PHILIPS 1982 mod note
for PM3262 family.

4.1. UNIT 7 (FOCUS UNIT) : /04 AFS.

MAT 1063

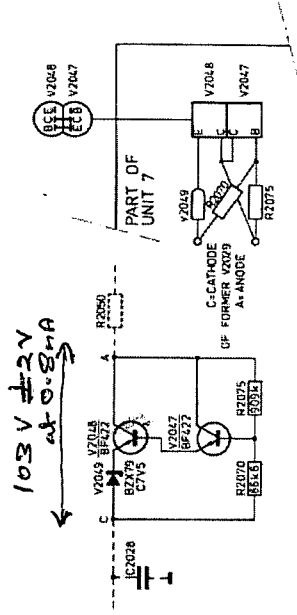
Replace neon stabilisation tube V 2029 by an electronic circuit consisting of 2 transistors V 2047, V 2048 (BF 422, 4822 130 44108), 1 zenerdiode BZX 79 C 7V5 (4822 130 30861) and 2 resistors 909 kohm (5322 116 54408) and 86,6 kohm (5322 116 54692).

For circuit diagram and lay-out of this circuit see figure below.

This modification is necessary because the neon stabilisation tube will soon not be available.
